AGENDA
NOTICE AND CALL OF SPECIAL MEETING OF THE
CITY COUNCIL OF THE CITY OF MORENO VALLEY

TITLE: A PUBLIC HEARING REGARDING AN APPEAL OF THE PLANNING COMMISSION DENIAL OF A ZONE CHANGE (PA08-0098) FROM BUSINESS PARK (BP) TO LIGHT INDUSTRIAL (LI) FOR A 55 ACRE SITE FOR THE WEST RIDGE COMMERCE CENTER PROJECT. THE PROJECT ALSO INCLUDES A PLOT PLAN (PA08-0097) FOR A 937,260 SQUARE FOOT WAREHOUSE FACILITY; TENTATIVE PARCEL MAP NO. 36207 (PA09-0022) TO CREATE A SINGLE PARCEL; AND A MUNICIPAL CODE AMENDMENT TO PROVIDE A MINIMUM SEPARATION/BUFFERING OF WAREHOUSE/INDUSTRIAL FACILITIES OVER 50,000 SQUARE FEET FROM ADJACENT RESIDENTIAL DISTRICTS. AN ENVIRONMENTAL IMPACT REPORT HAS BEEN PREPARED FOR THE PROJECT. THE PROJECT SITE IS LOCATED ON THE SOUTH SIDE OF STATE ROUTE 60, ON THE NORTH SIDE OF EUCALYPTUS AVENUE AND APPROXIMATELY 650 FEET WEST OF REDLANDS BOULEVARD. THE APPLICANT IS RIDGE RANCHO BELAGO, LLC.

GEOLOGIC MAP
PROPOSED WEST RIDGE BUSINESS CENTER
MORENO VALLEY, CALIFORNIA

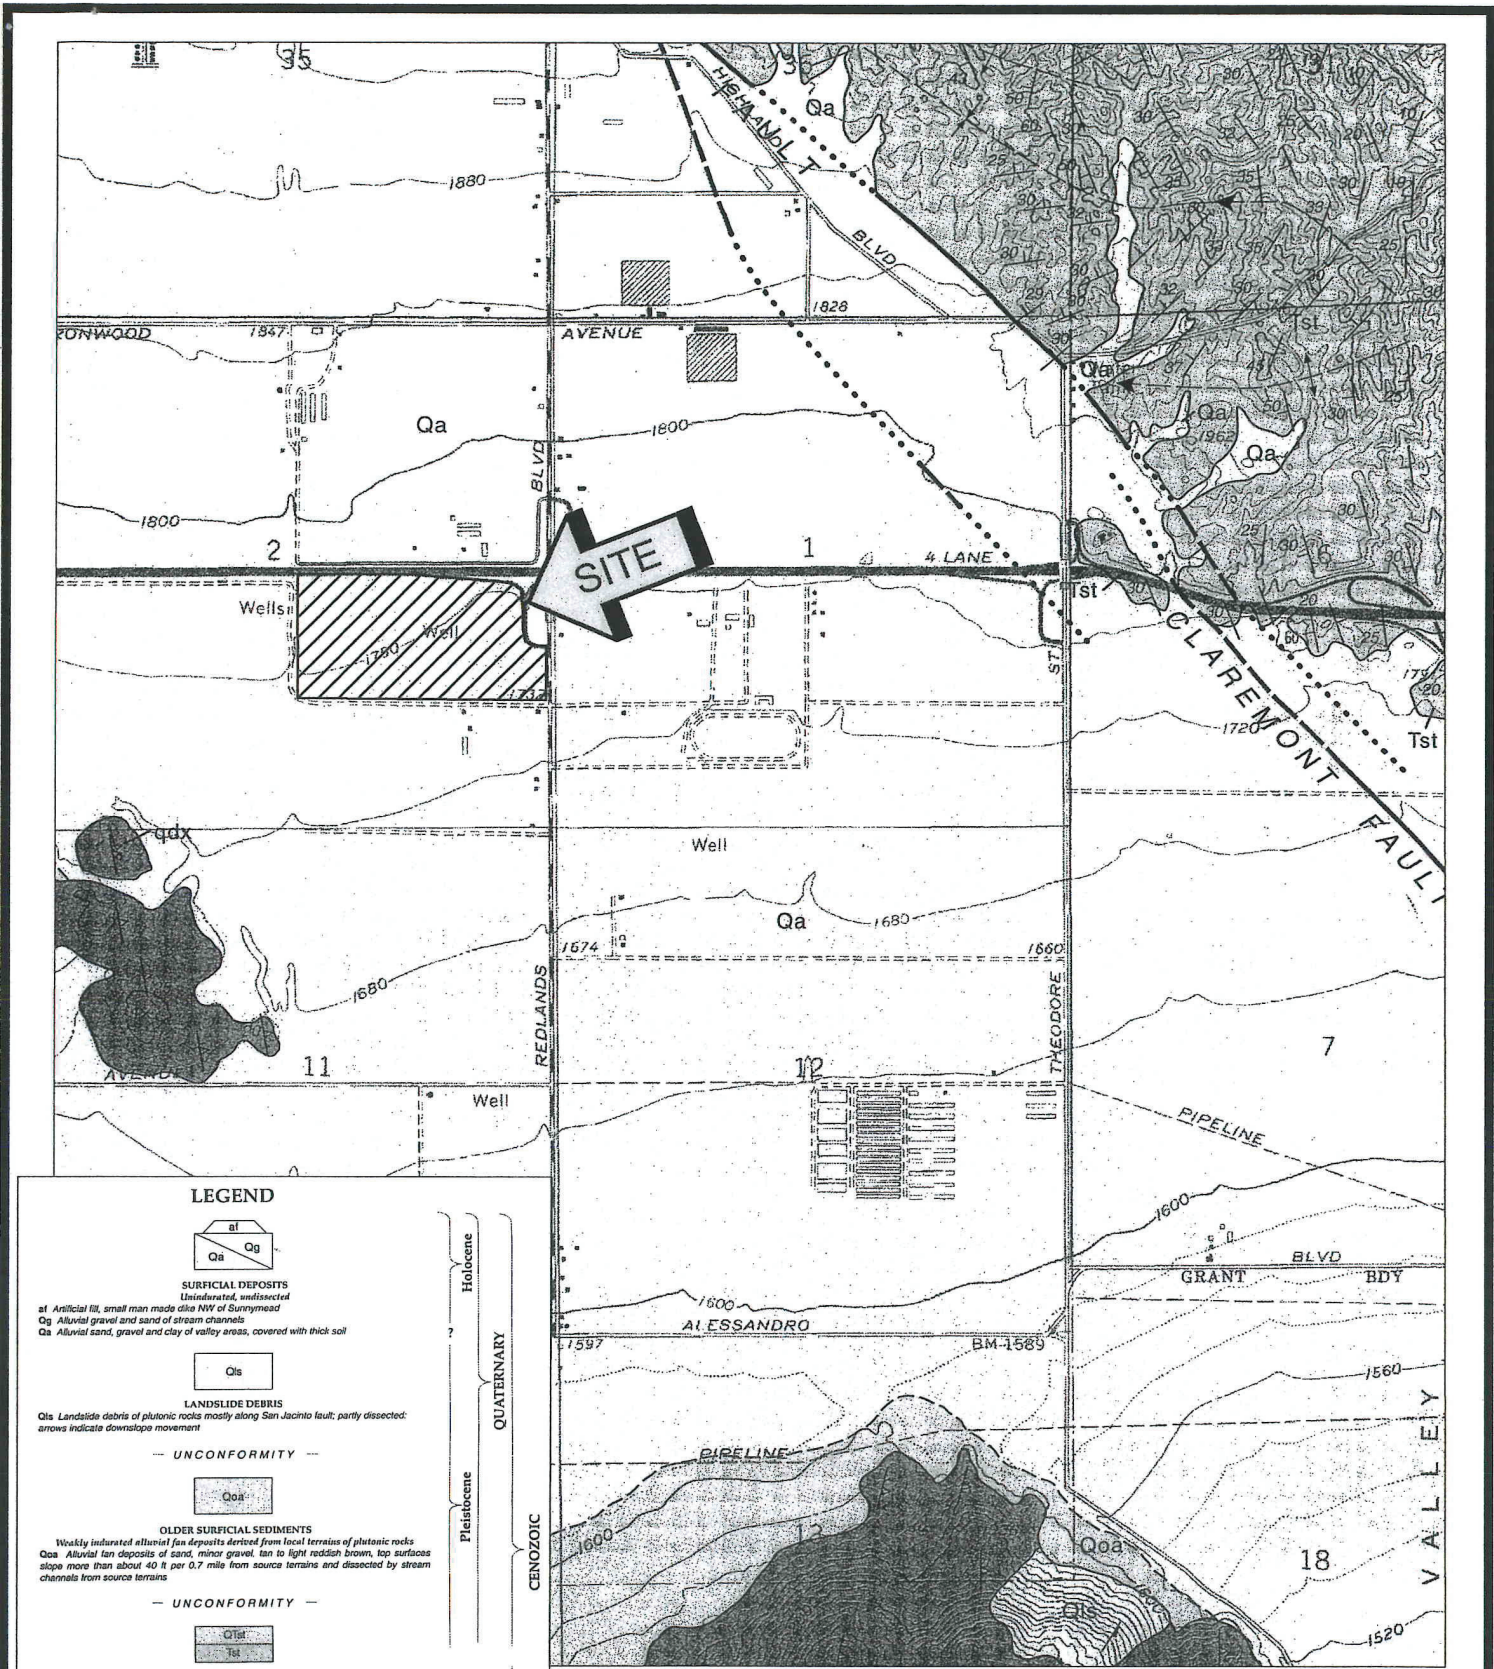
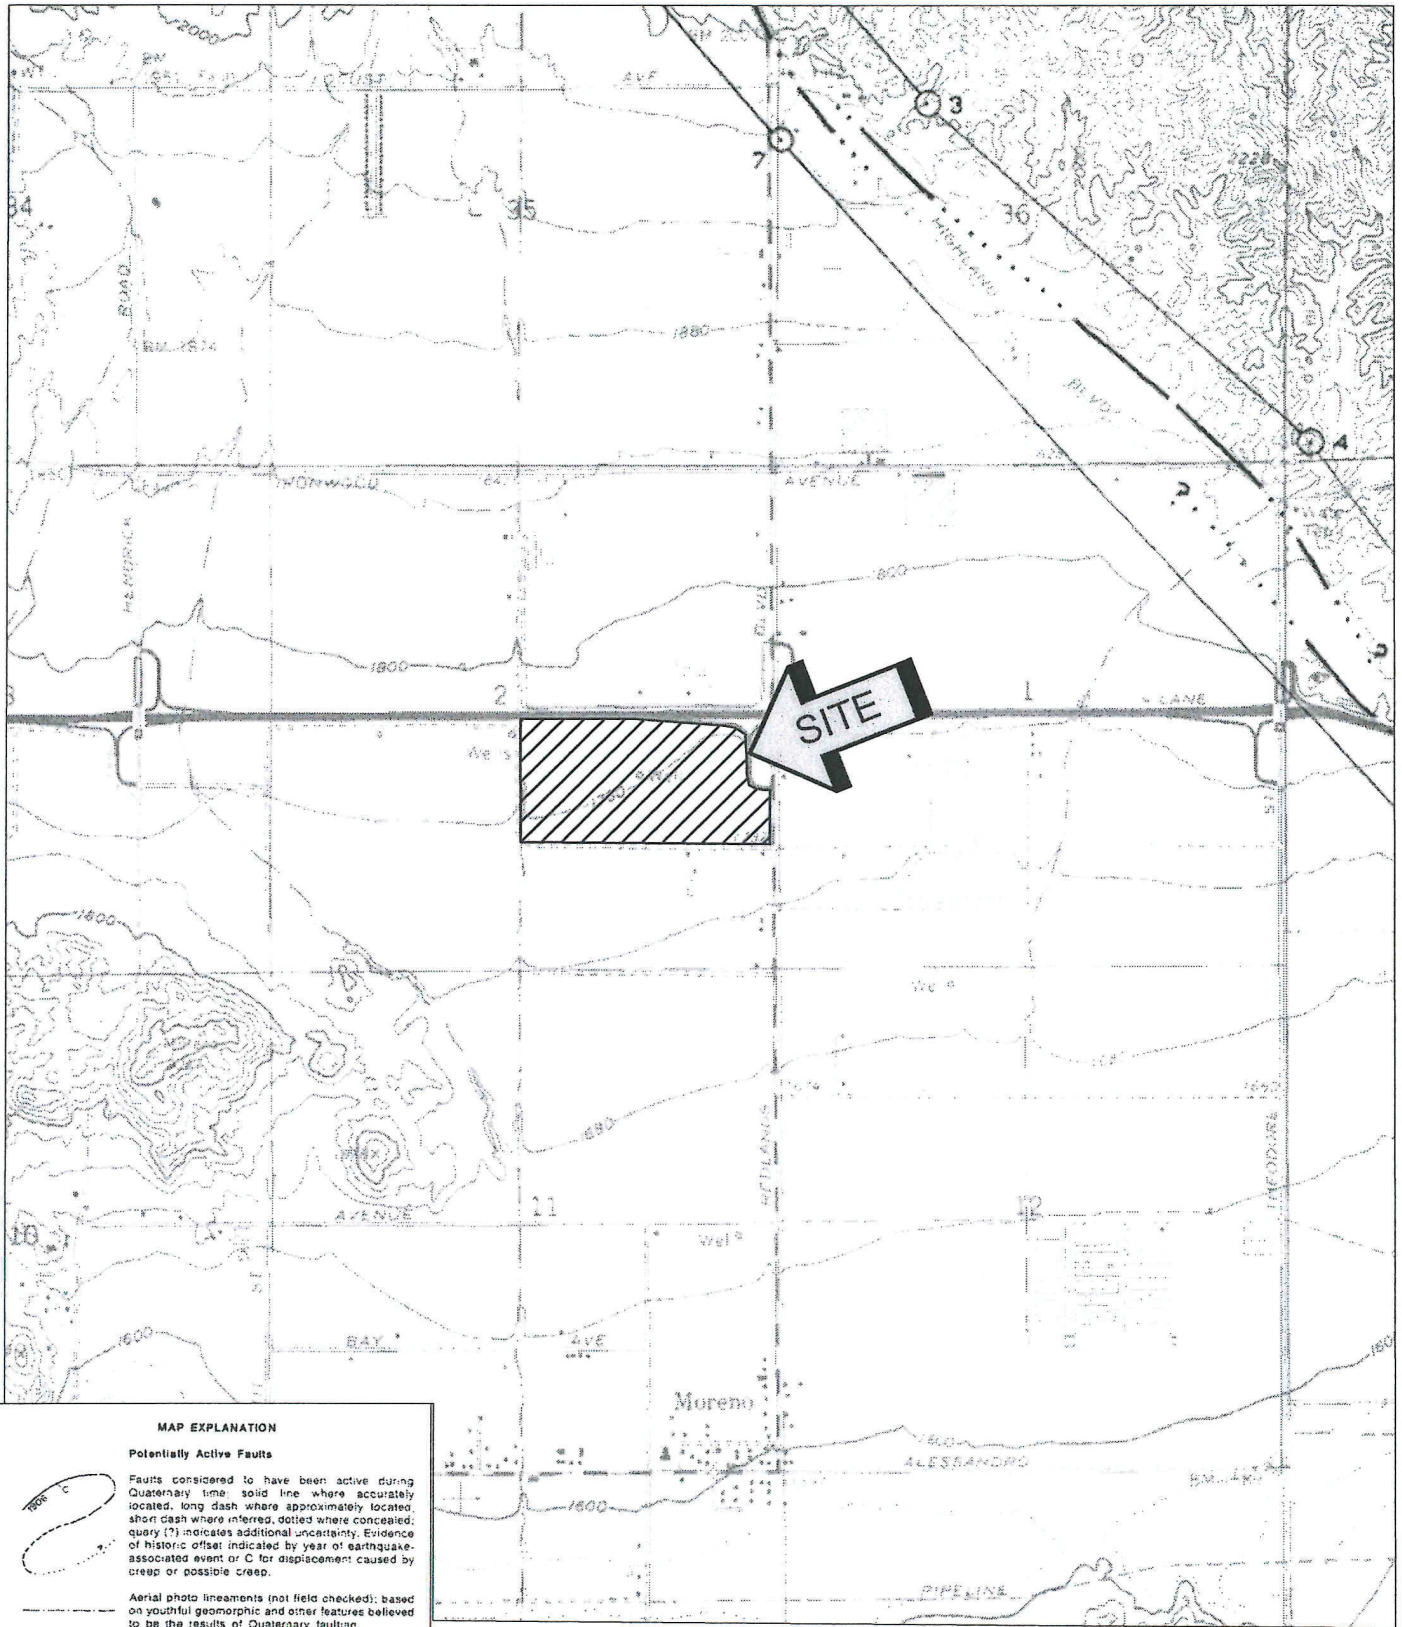
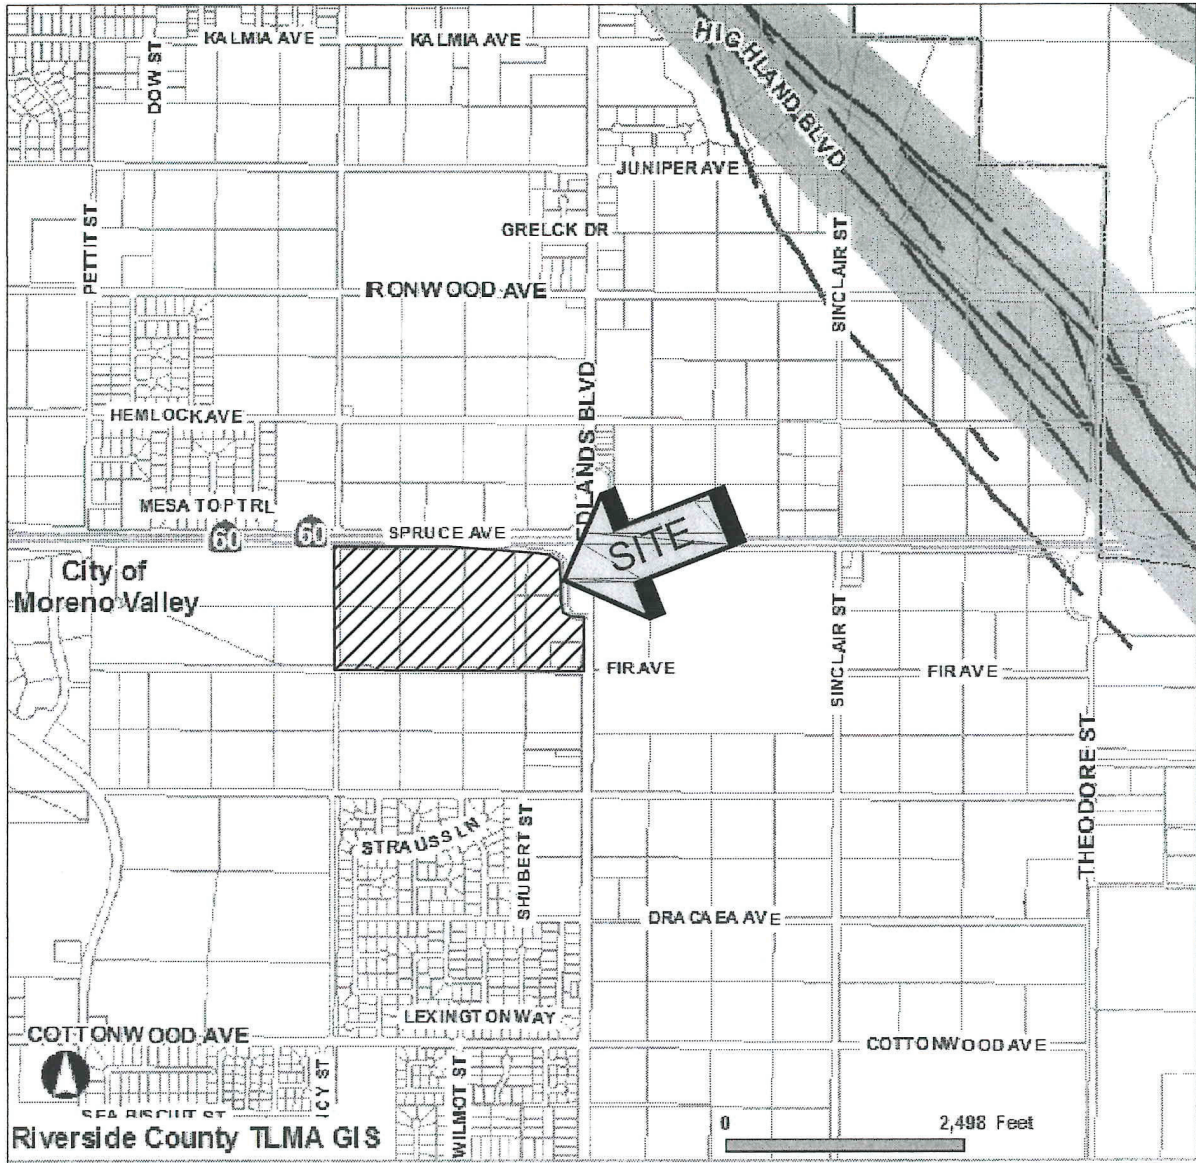
Copies of these maps are included on the following pages for ease of reference, and have also been incorporated in Final EIR Section 2.0, Revisions and Errata.
